AP - 66

**GENERAL
CORRESPONDENCE**

RE: Junction N-5, T20S, R37E, Section 5, Unit N; NMOCD Case # 1R0427-90

RE: M-5 Redwood Tanks, Section 5 T20S R37E Unit M; case number 1R0426-36

Because the site is so small, we elected to show the location of the monitoring well relative to the former EOL box with Figure 7 of the Corrective Action Plan. Figure 7 of the CAP is reproduced herein.

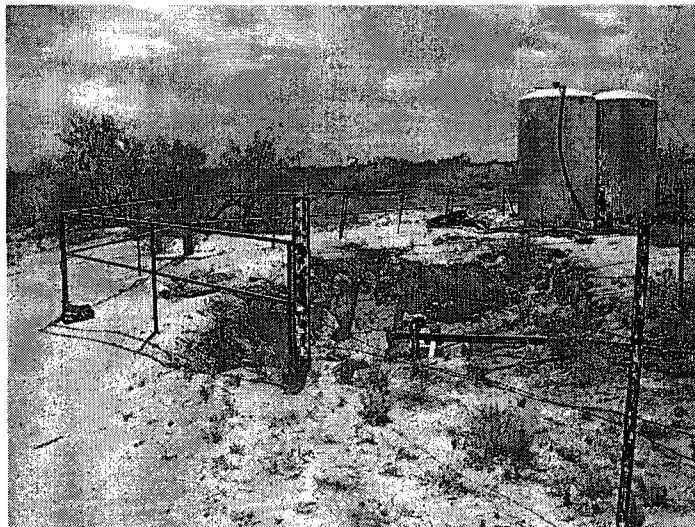
1. Photos of the site before, during and after excavation.
2. Photos of the liner and backfill.
3. A plat showing location of all monitor wells and a chloride/TDS chronologic summary table for these wells.
4. A copy of the NMOCD approved work plan (July 02, 2003) that R.T. Hicks is working under.
5. A copy of the Hicks January 30, 2004 final corrective action plan.

Note the red monitor well protection box with the concrete pad in the left center of the image – that is the monitoring well discussed in the CAP. The former EOL box excavation is in the center of the photograph. No other monitoring wells exist at this site. The monitoring well lies to the south-southeast of the former EOL, directly down gradient of ground water flow. The image on the CD titled "Northwest ZH 12.8.04" shows that the site remains relatively unchanged since Figure 7 of our CAP. The Corrective Action Plan, as submitted to NMOCD via email on 1/30/2004 (from Katie Lee of R.T. Hicks Consultants to Wayne Price), is on the CD in the zip-file folder titled "ZH_CAP".
